# HERITAGE HIGH SCHOOL NEW CLASSROOM BUILDINGS, INCREMENT 2. Bid Clarification 02

May 25<sup>th</sup>, 2021

DSA File Number: 7-H4  
DSA Application Number: 01-119268  
PTN: 61721-77

**Architect's Project No.:** 1870.00

### E-B3.1

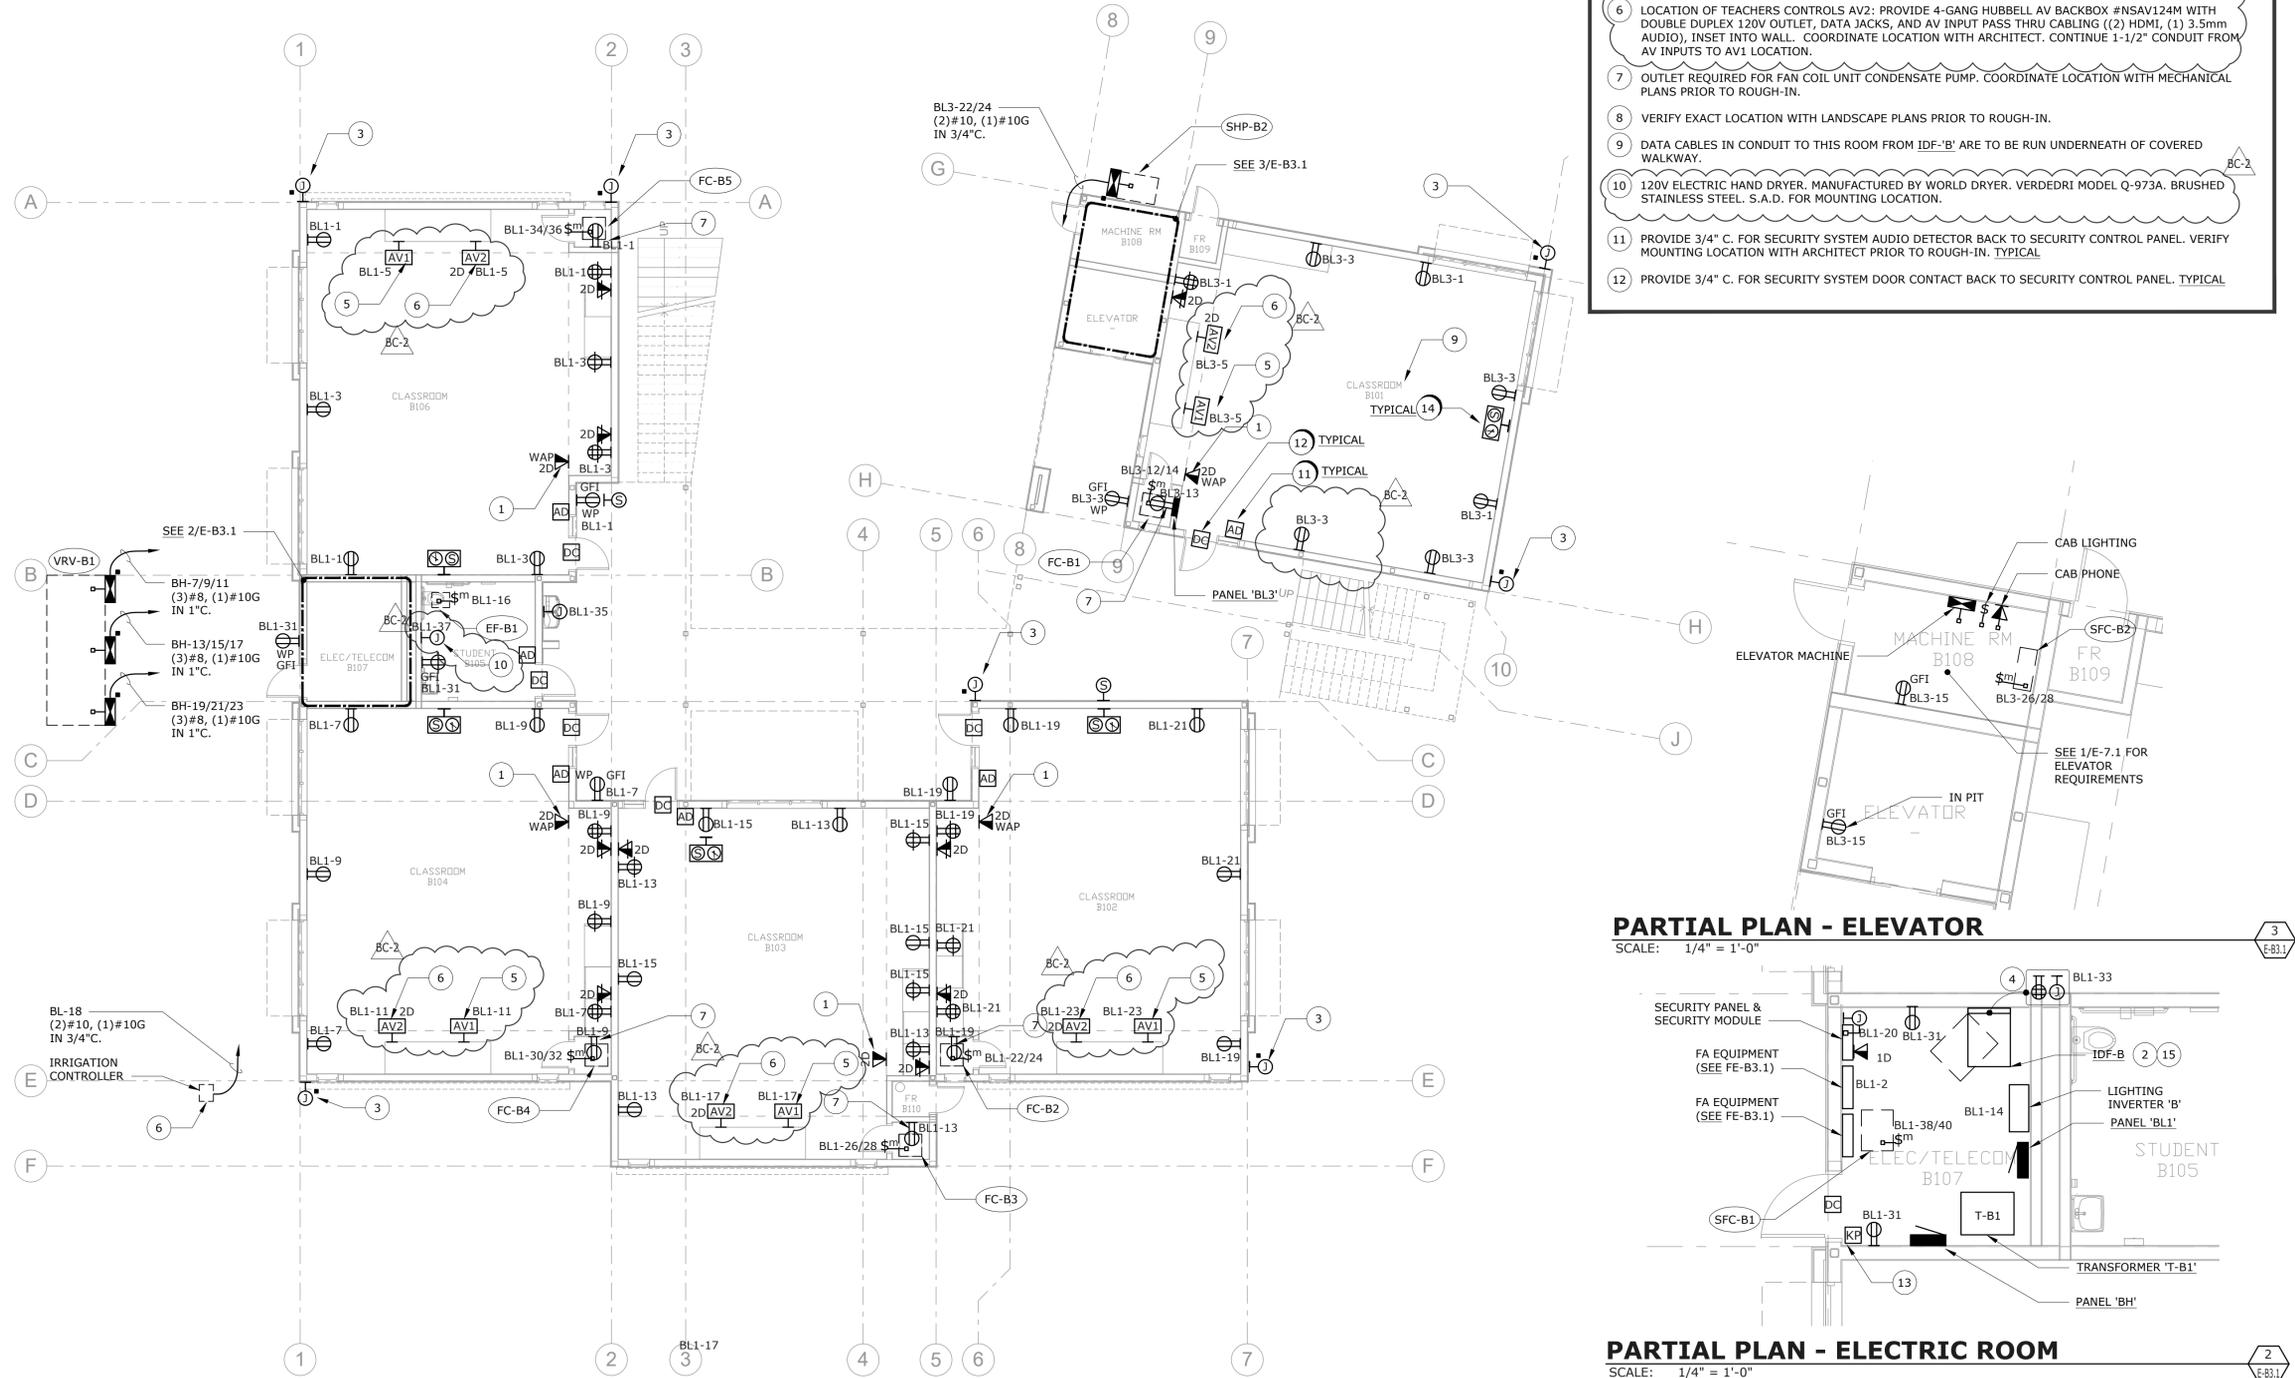
**Q:** Audiovisual - Numbered Sheet Notes # 13 and 14 on Sheet E-A3.1 describe the classroom av system components. However; The type of connectivity and cabling required (HDMI, etc.) is not specified. At the job walk the district representative expressed that the av system components were intended to be contractor furnished and installed and that the systems should be the same as was specified on the Liberty high school administration and student commons project. That project called for each room to have a (2) HDMI plus (1) 3.5mm audio input wall-plate/cabling system and a 'Topcat' Access

Audio System with owner furnished projectors and mounts. Please clarify what is to be provided for the AV system at Heritage high school.

**A:** Modified notes on sheets E-A3.1, E-B3.1, E-B3.2 to designate the cabling.

**BC 02.01**

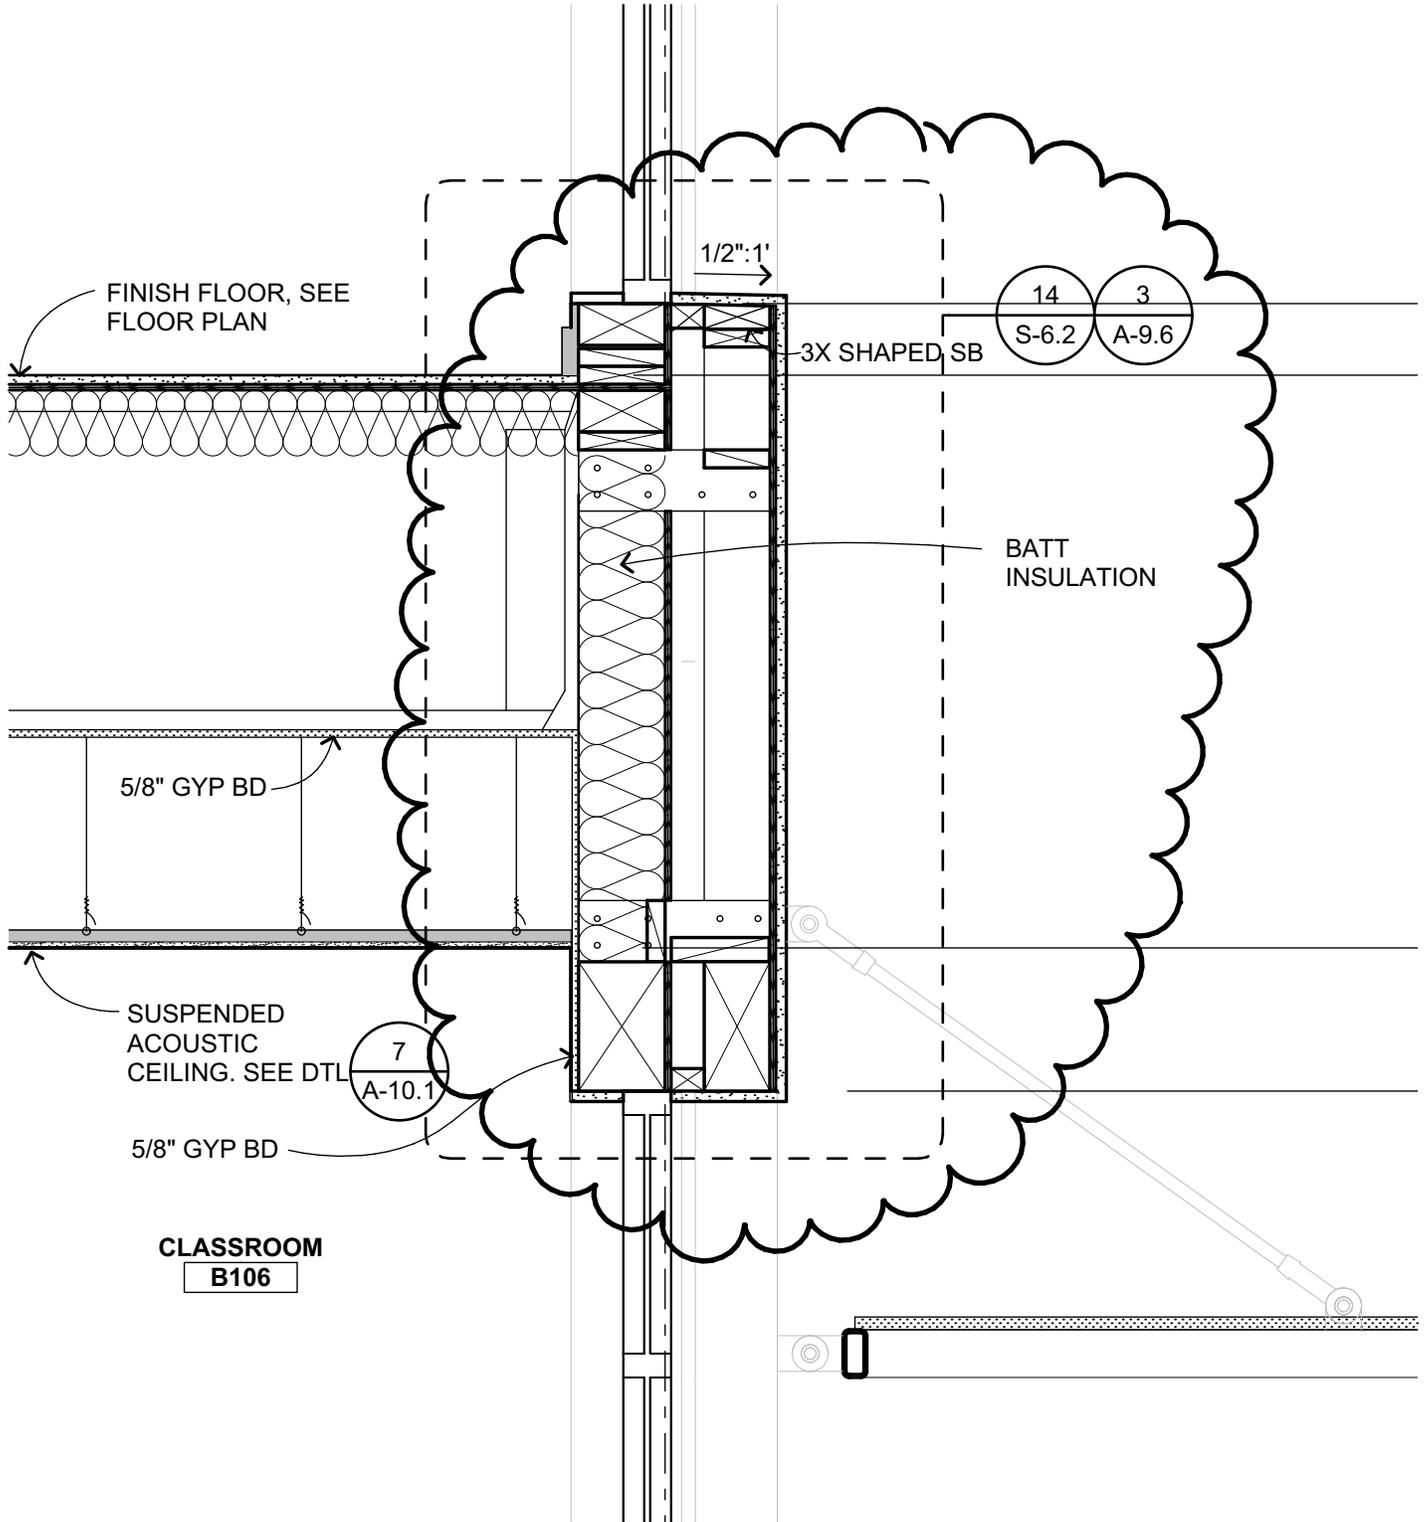
Sheets A-A5.1, A-B5.1 and A-B5.2 EXTERIOR ELEVATION KEYNOTES  
Revise in accordance with the attached drawing BC 02.01.

**BC 02.02**

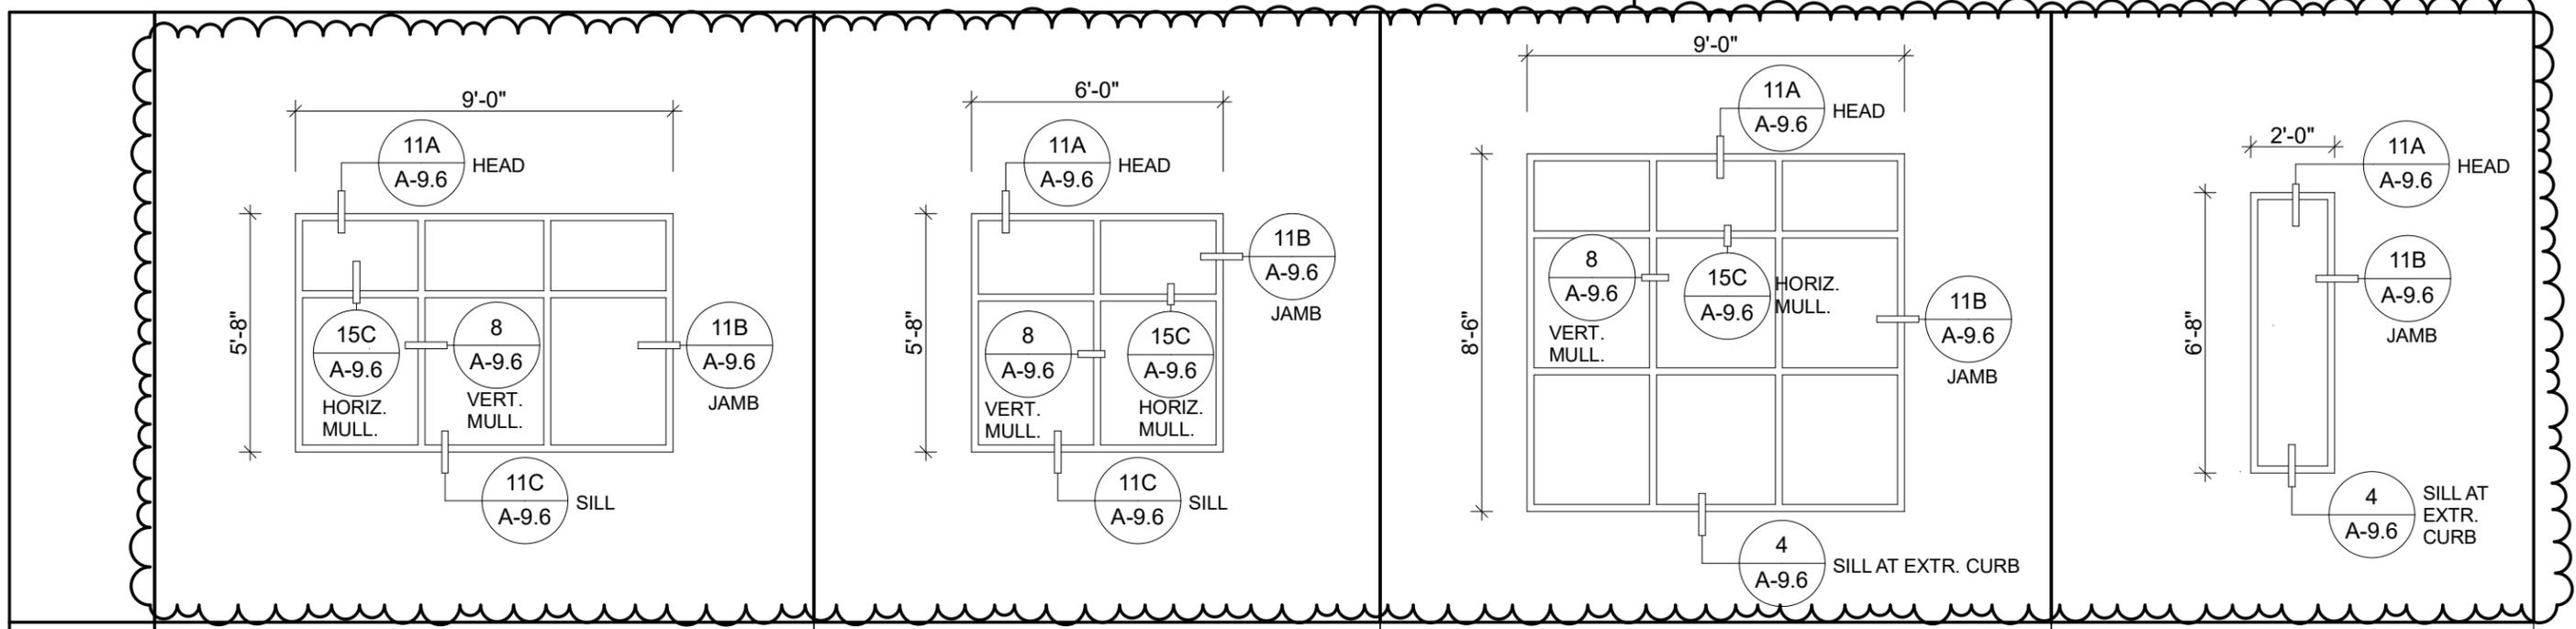
Sheet A-B6.4 BLDG-B WALL SECTIONS  
Revise in accordance with the attached drawing BC 02.02.

**BC 02.03**

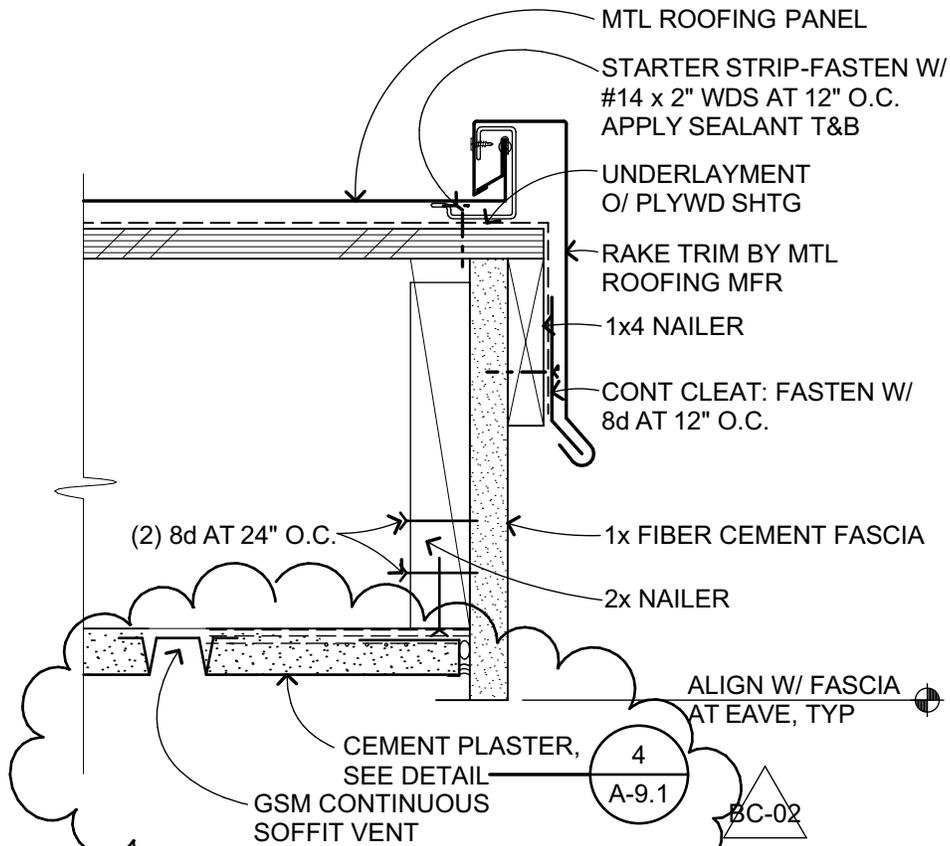
Sheet A-8.1 DOOR & WINDOW SCHEDULE  
Revise in accordance with the attached drawing BC 02.03.

**BC 02.04**

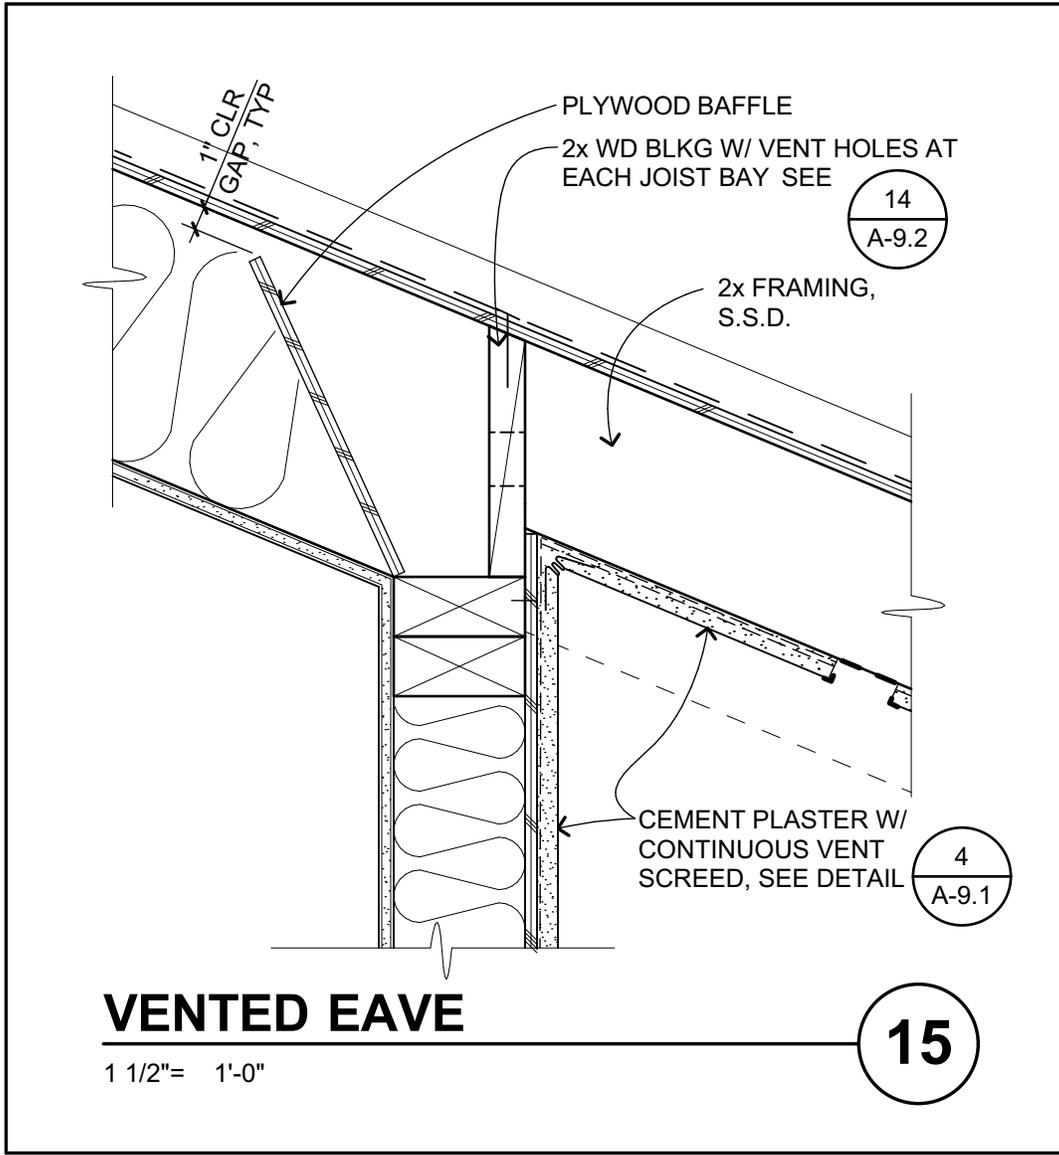
Sheet A-9.2 ROOF DETAILS  
Revise in accordance with the attached drawing BC 02.04.

**BC 02.05**

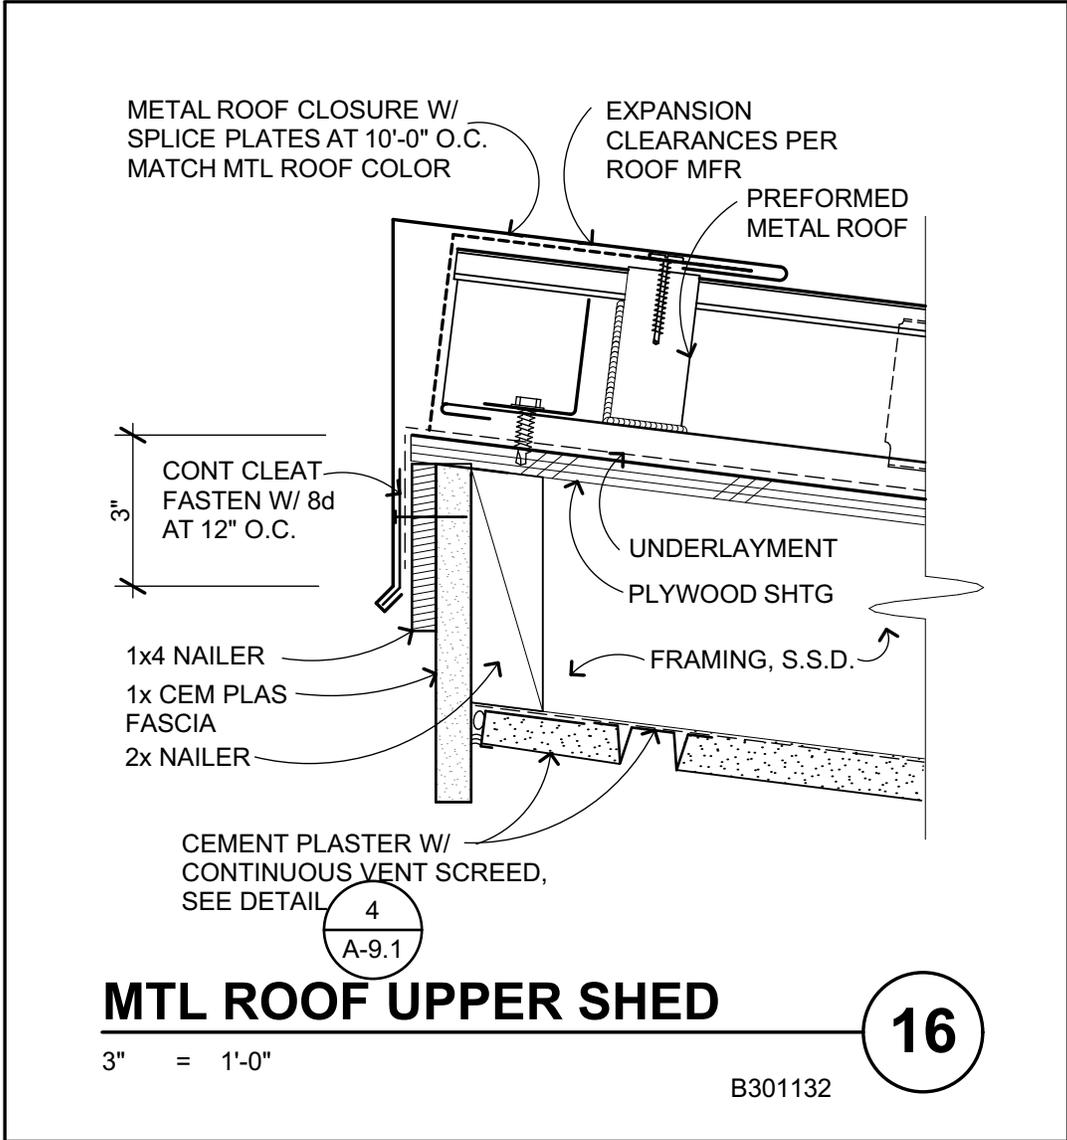
Sheet A-9.2 ROOF DETAILS  
Revise In accordance with the attached drawing BC 02.05.
